# Access Compliance Report

## Public Rights-of-Way

Intersection ID: 27760	Main Street: BALLANTYNE_COUNTRY_CLUB_DR	Cross Street: BALLANTYNE_CROSSING_AV	Location: NW
ADA ID: B37C805320C7	Ramp Type: Perp	Initial Pass/Fail: Fail	Overall Compliance: No
Severity Score: 22.5			
Codes/Mitigation Info/Possible Solution		Field Measurements/Component Compliance

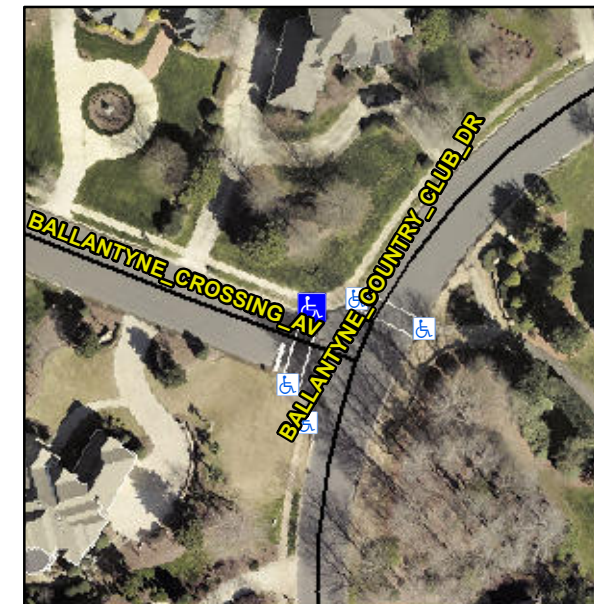
**Not Found, R304.5.1, R304.2.2, R304.5.3**

Compliance	Description	Data	Compliance	Description	Data
N/A	Ramp Length (in)	47.0	No	Ramp Slope (%)	8.9
No	Ramp Width (in)	43.0	No	Ramp XSlope (%)	4.6
N/A	Flare Type LT	N/A	N/A	Flare Type RT	N/A
N/A	Flare Slope LT (%)	N/A	N/A	Flare Slope RT (%)	N/A
N/A	Flare Traversable LT?	N/A	N/A	Flare Traversable RT?	N/A
N/A	Landing Length (in)	N/A	N/A	DWS Provided?	N/A
N/A	Landing Width (in)	N/A	N/A	DWS Contrast?	N/A
N/A	Landing Slope (%)	N/A	N/A	DWS Length (in)	N/A
N/A	Landing X Slope (%)	N/A	N/A	DWS Full Width?	N/A
N/A	Landing Curb? (Y/N)	N/A	N/A	DWS Offset (in)	N/A
N/A	Shared Landing?	N/A			
N/A	Gutter Ponding?	N/A	N/A	Gutter Slope (%)	N/A
N/A	Gutter Lip Ht (in)	N/A	N/A	Gutter X Slope (%)	N/A
N/A	Painted X Walk1?	Yes	N/A	Painted X Walk2?	N/A
	X Walk 1 Direction	To SW		X Walk 2 Direction	N/A
N/A	X Walk 1 Width (in)	102.0	N/A	X Walk 2 Width (in)	N/A
	X Walk 1 Slope (%)	6.2		X Walk 2 Slope (%)	N/A
	X Walk 1 X Slope (%)	1.6		X Walk 2 X Slope (%)	N/A

**Remove & Replace Entire Ramp.**
